Swan River Crossing Project

*Review of Current Design, Released by
Government for Public Comment*

City of Fremantle

October 2022

CROSS-SECTIONS

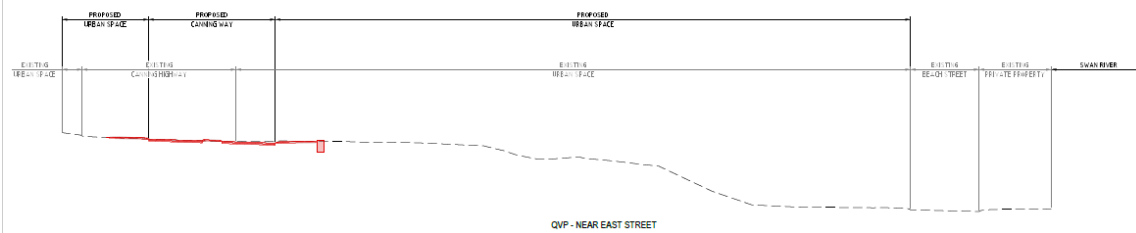
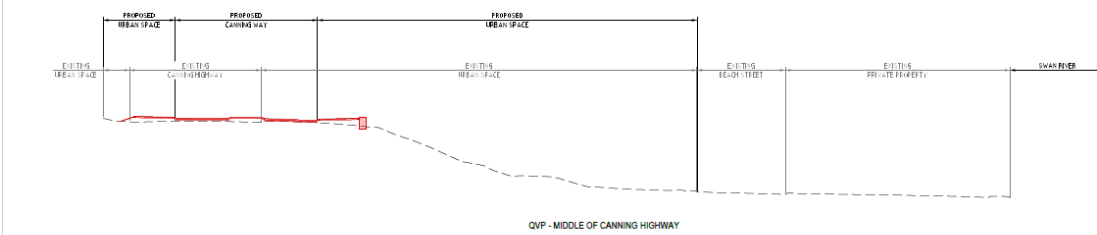
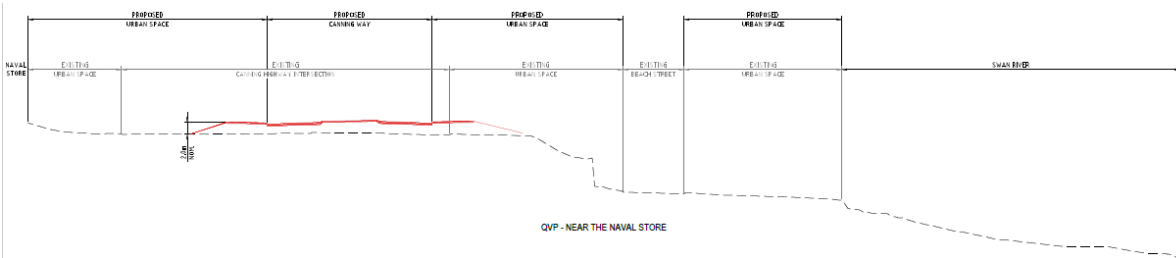
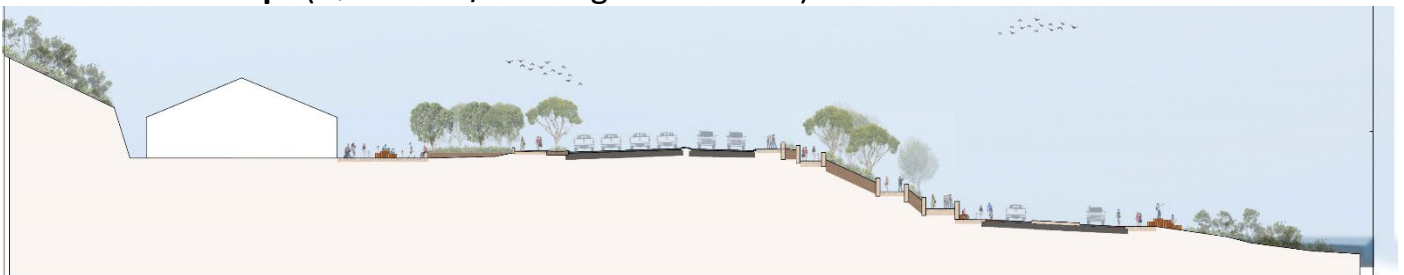
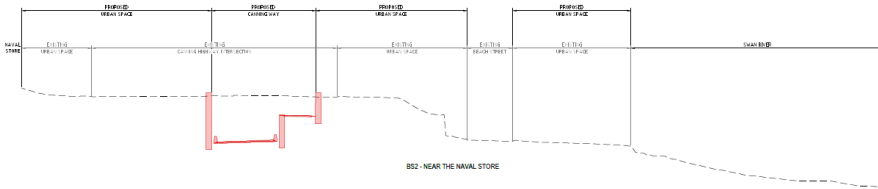
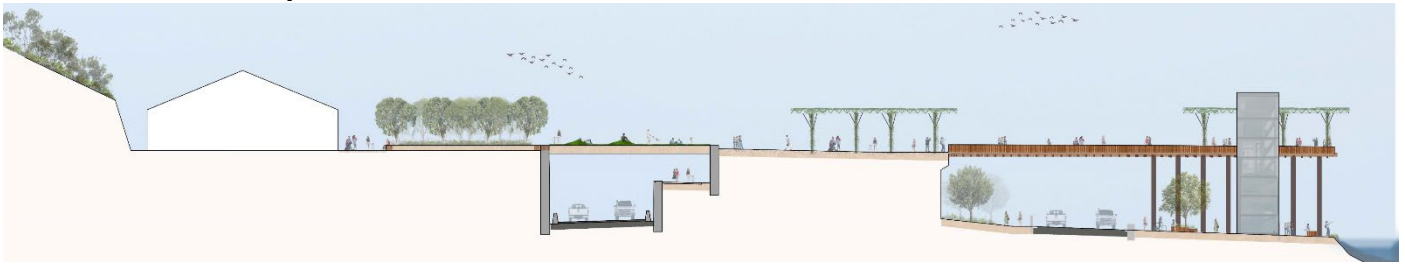
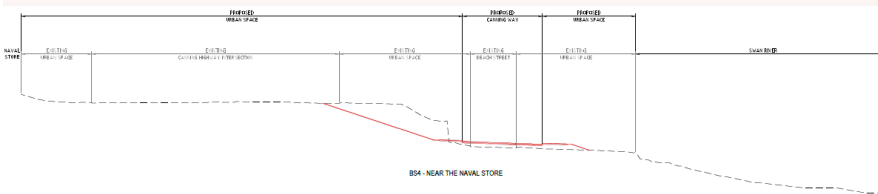
The following cross-sections show the differences between the three designs that evolved over the past 12 months, in the following three locations:

1. Revised Concept (Queen Vic/Canning Intersection)

2. Modified Concept (Trench)

3. Refined Concept (Beach St Re-alignment)

DIAGRAM: Place / Urban Design Opportunities

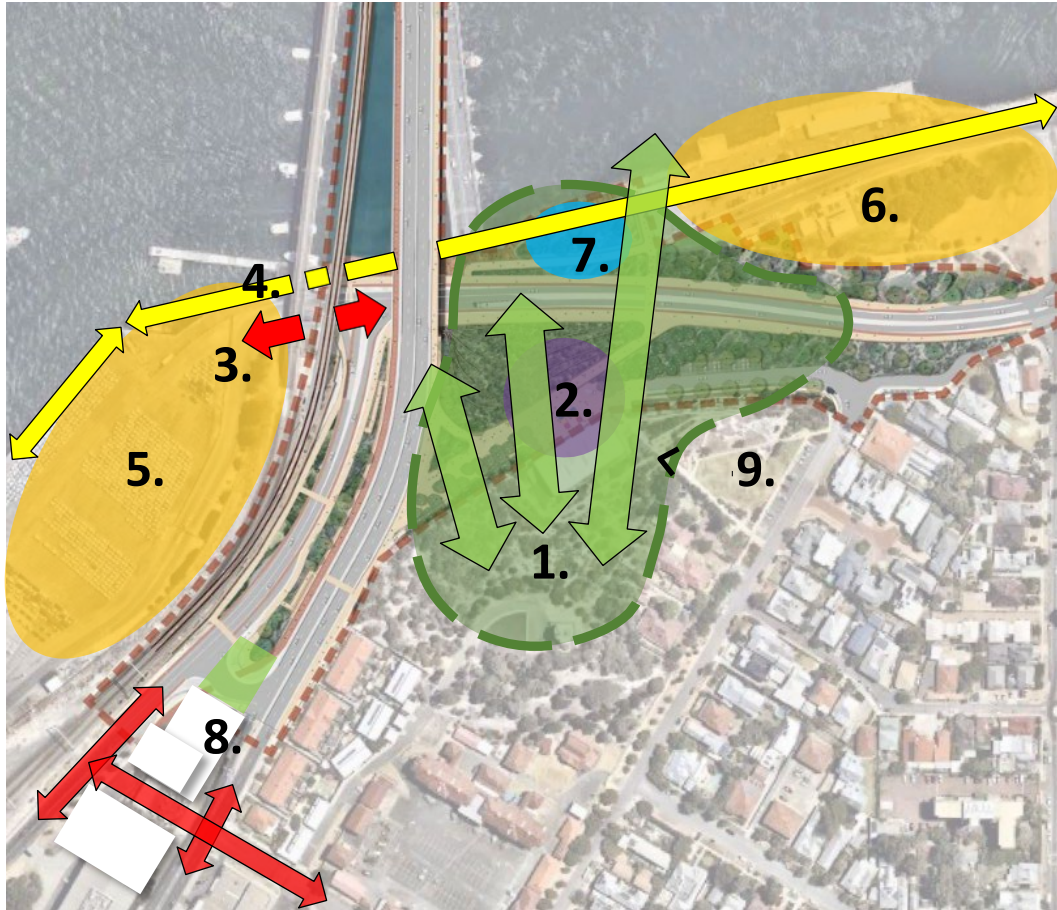
1. Connect Cantonment Hill to Foreshore.
2. Activate Naval Store Forecourt.
3. Road Connection to Future Port Redevelopment.
4. Fully connected pedestrian foreshore walk / boardwalks.
5. Future Redevelopment.
6. Future Foreshore Enhancements.
7. WSUD: nutrient stripping wetlands / swale to treat stormwater.
8. Potential to replace 'hairpin' road connection with urban intersections and redevelopment that 'fit the grid/grain' (on Burt Street alignment).
9. Potential area of public realm that could be subjected to Community Design Ideas / Engagement.
